Village of Chenequa Plan Commission
Monday, January 13, 2025 at 6:00 p.m.
31275 W. County Road K, Chenequa, WI 53029

STAFF REVIEW

Subject: Site Plan Review

Property Address: 7131 N State Road 83

PLAT OF SURVEY

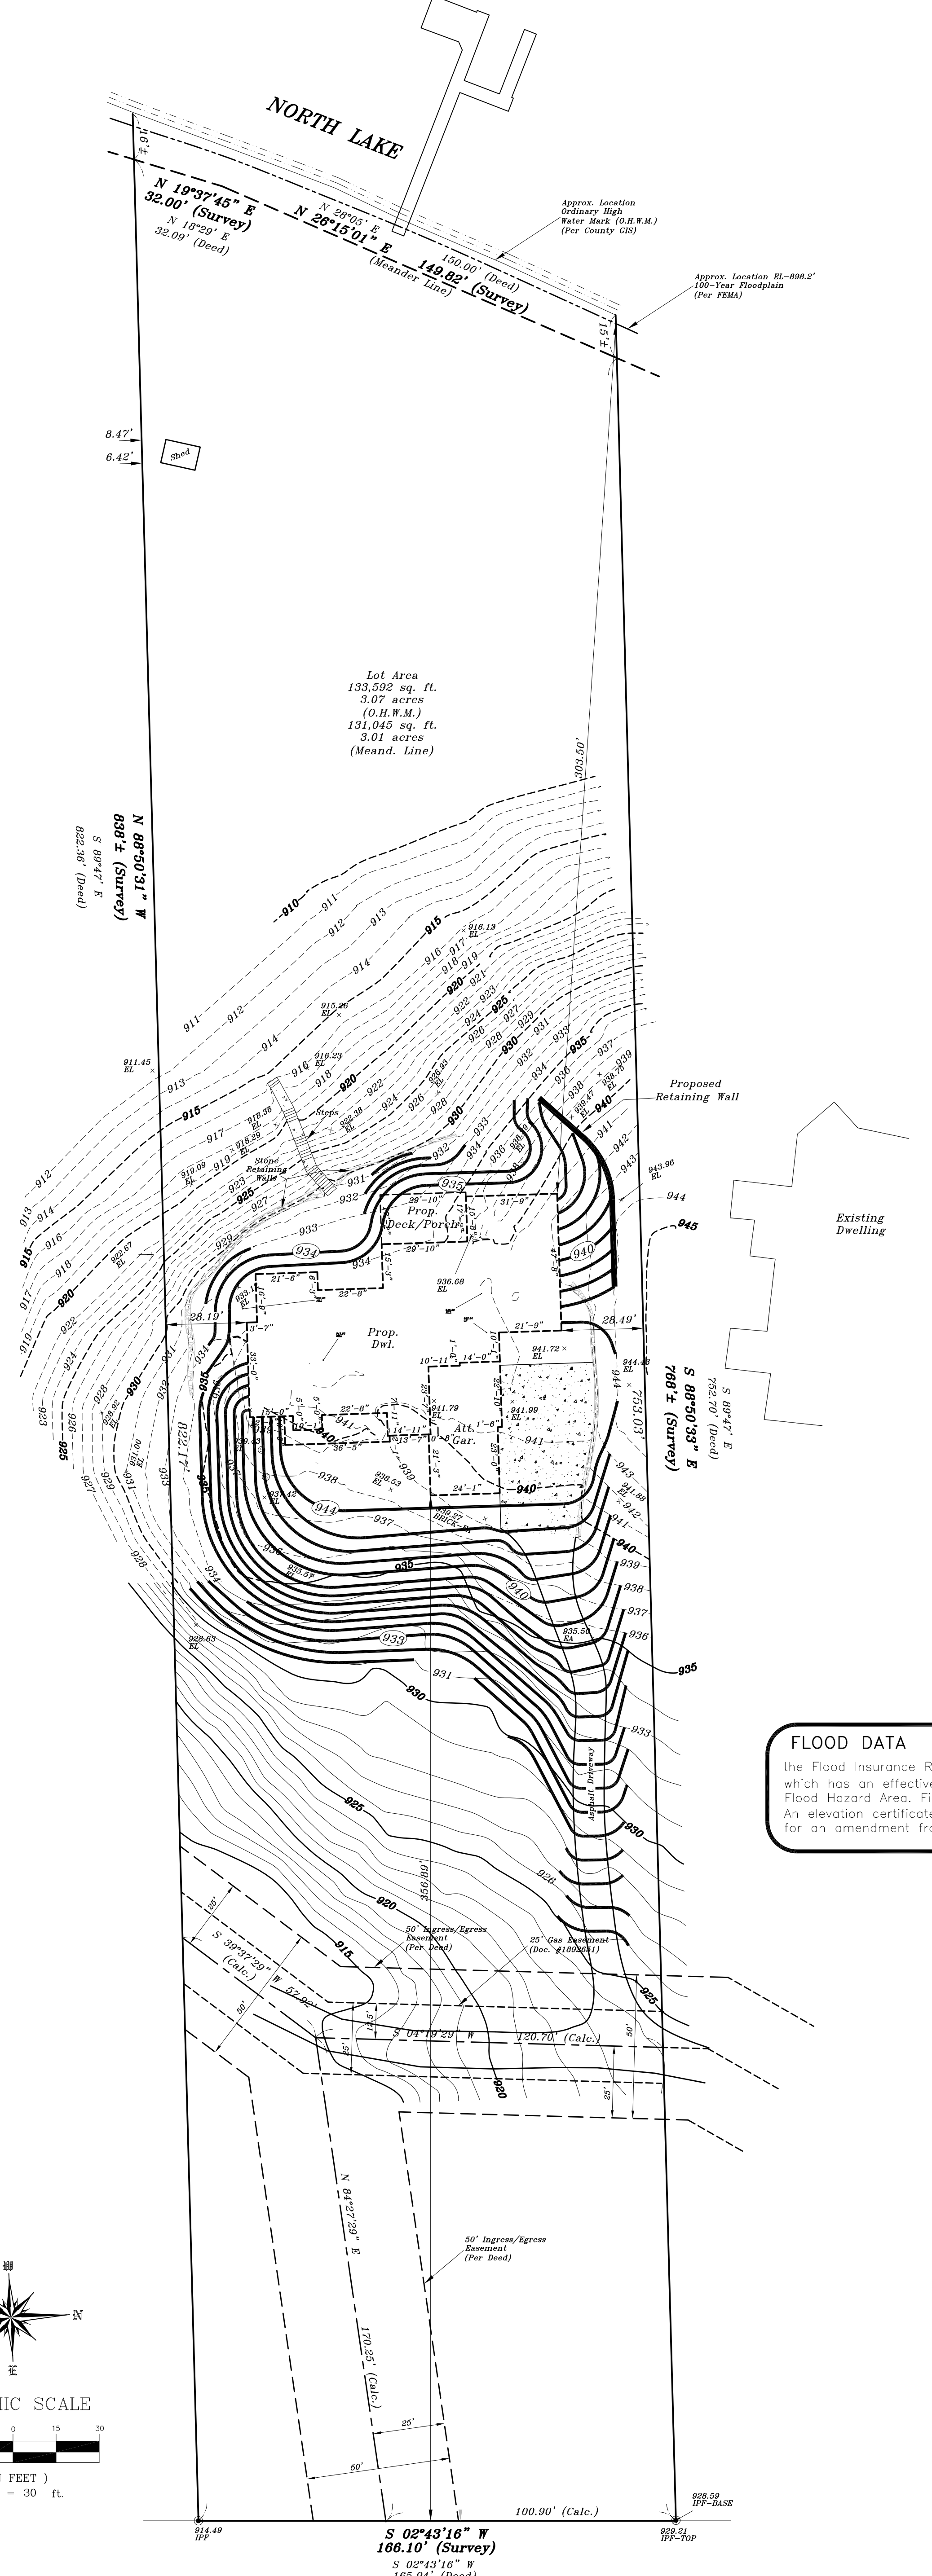
6. A site grading plan has also been submitted by Metropolitan Survey Service, Inc and is provided in the packet.
 - a. Included in this grading plan is a retaining wall on the north west side of the proposed dwelling.

- i. As proposed, this retaining wall is 10' off the north property boundary
 - ii. This retaining wall will be approximately 4.5' tall at the highest point

- iii. The retaining wall stone material will match the stone that is proposed to be used on the house.
 - b. Additionally, the provided grading plan shows the proposed changes around the new proposed dwelling. The most significant grade changes will be on the roadside of the proposed dwelling.

- c. This roadside grade change will result in a change in driveway pitch. As proposed, the new driveway does not exceed 12%. This is compliant with 5.23(4)(a).

FRONT AND SIDE ELEVATIONS
EXTERIOR LIGHTING PLAN
12-17-2024
PLAN COMMISSION REVIEW
NOT FOR CONSTRUCTION

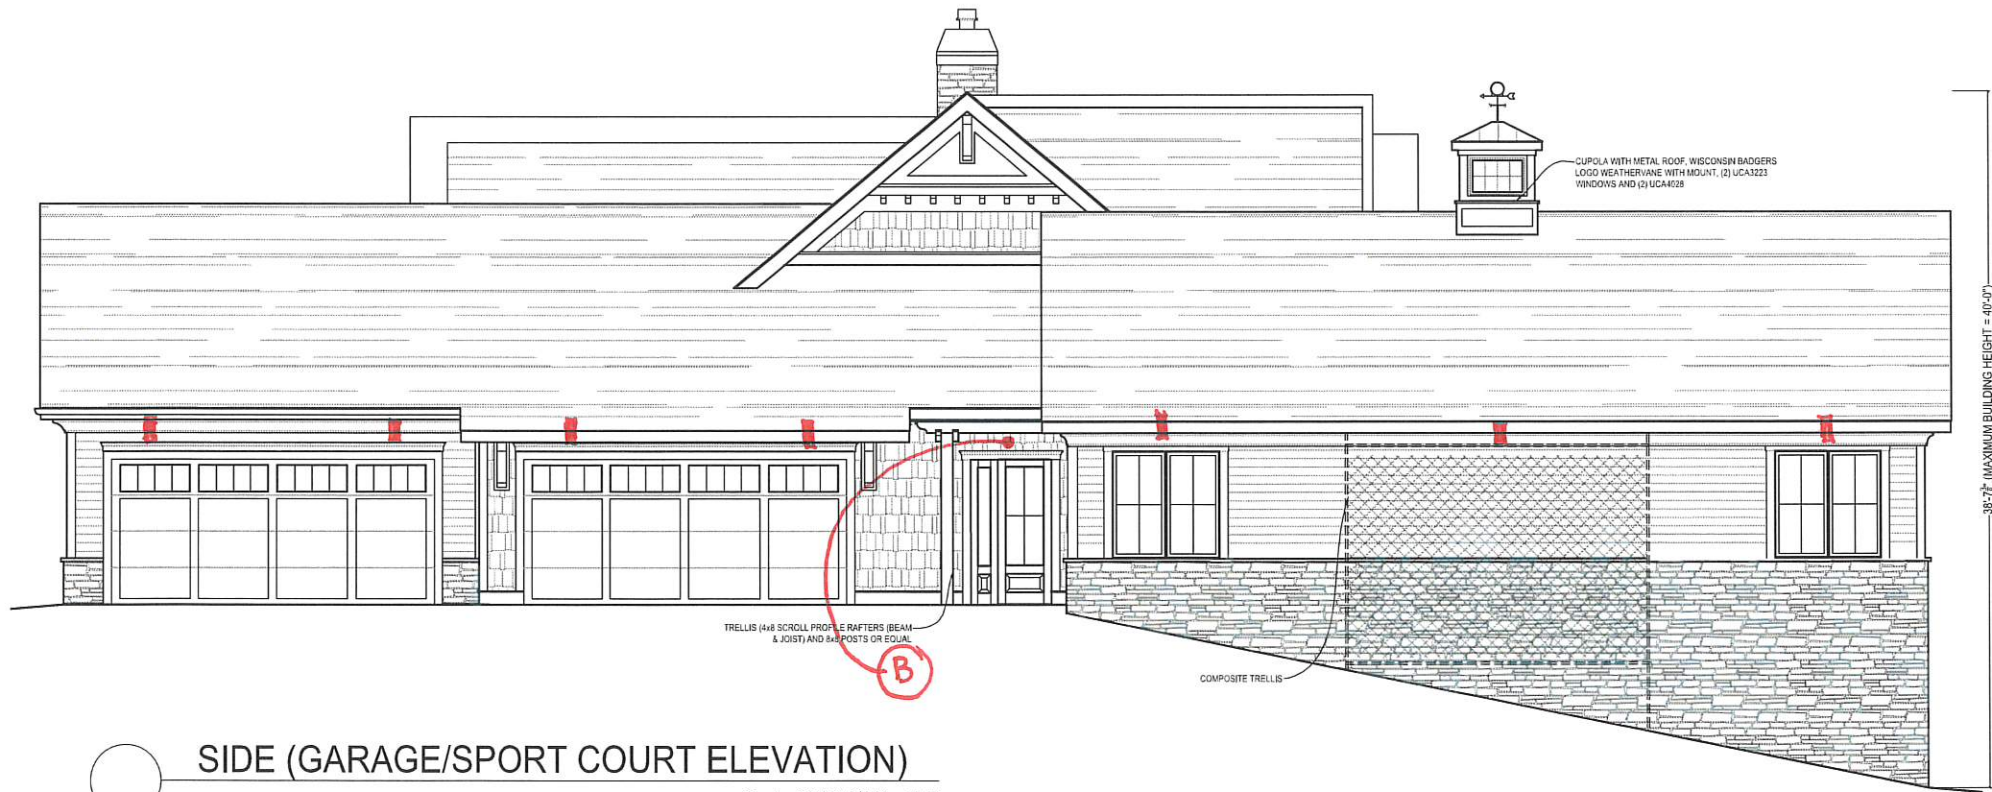
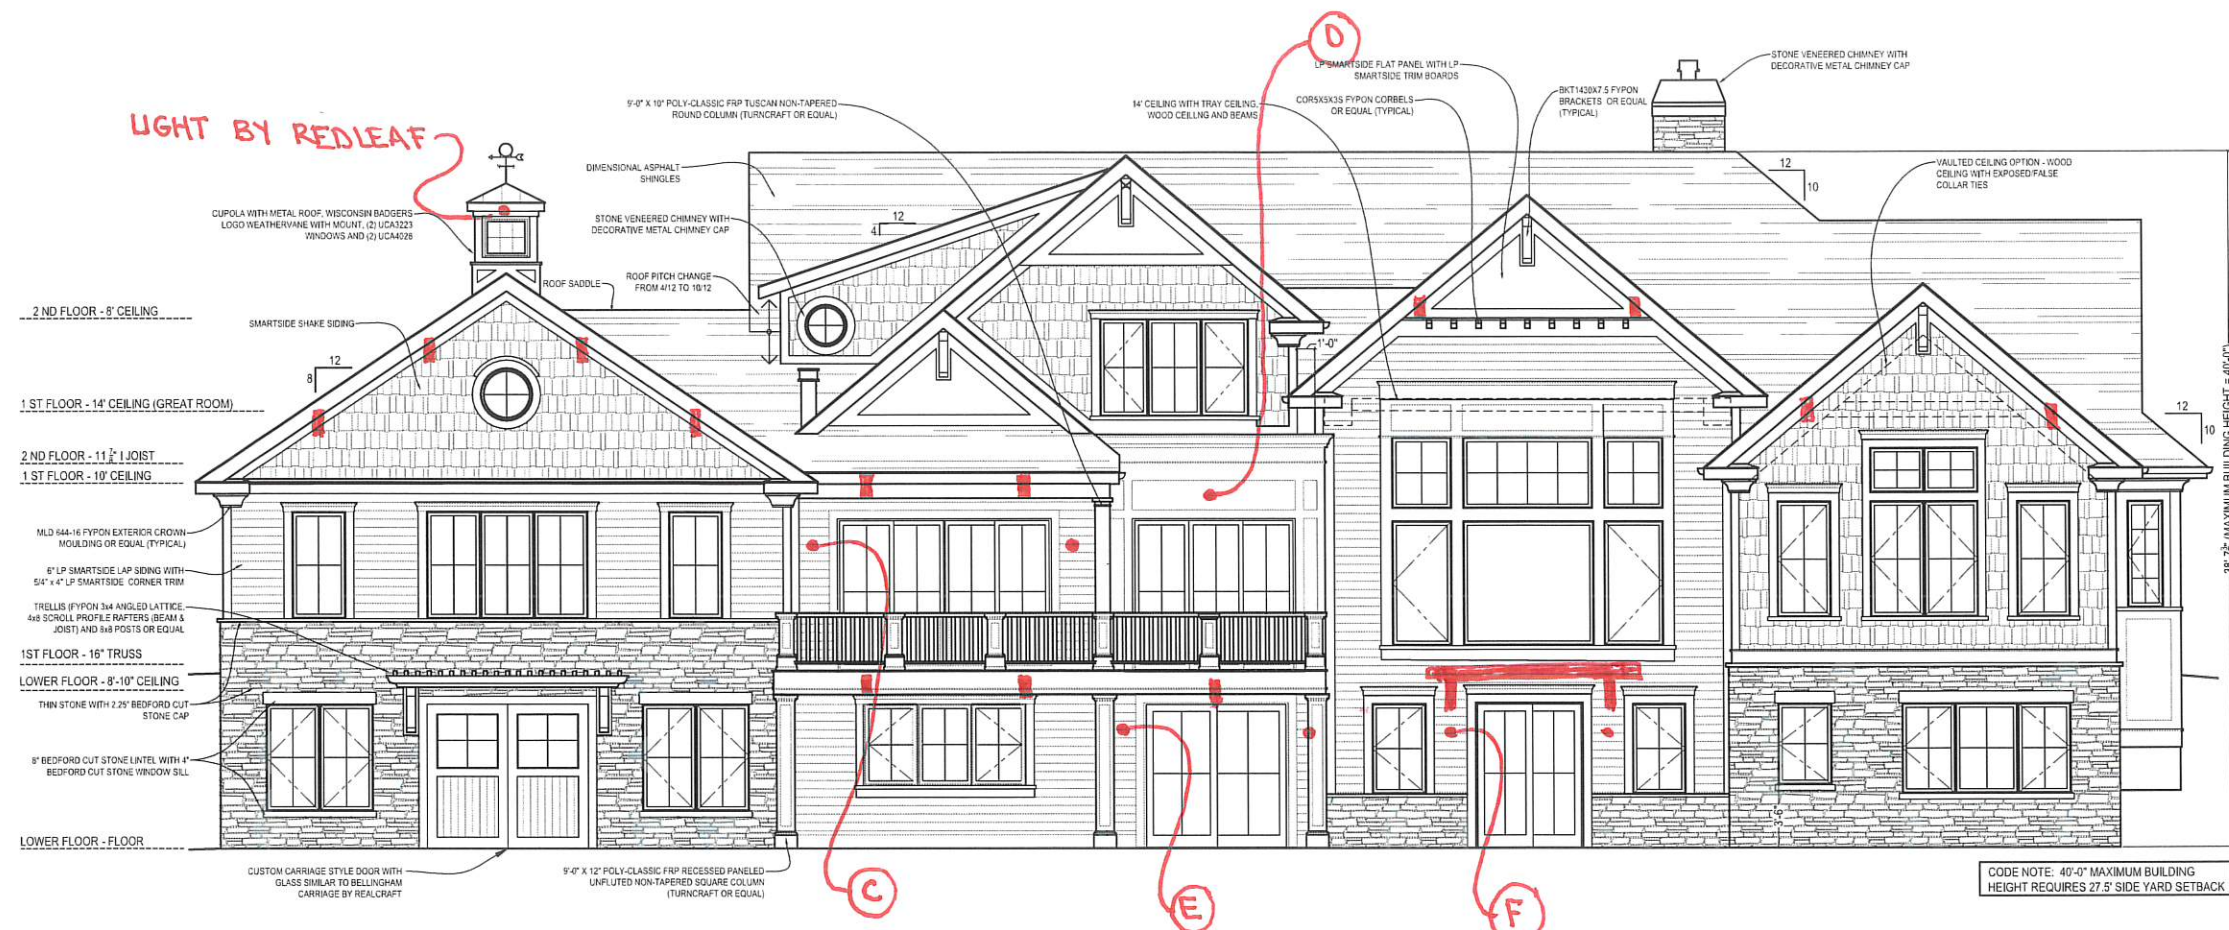
5. Two exterior light selections have been provided.
 - a. Wall mounted fixture
 - i. There are 9 proposed wall mounted outdoor fixtures
 - ii. These fixtures are 2700K and 275 lumens each

- iii. These fixtures have an integrated led that is recessed into the metal housing on top.
 - b. Soffit lighting
 - i. The applicant proposes 34 soffit mounted fixtures

- ii. These fixtures are 2700K and 500 lumens each
 - iii. The lighting element on these fixtures are recessed into the housing. If these fixtures produce light trespass or glare additional shielding may be required.
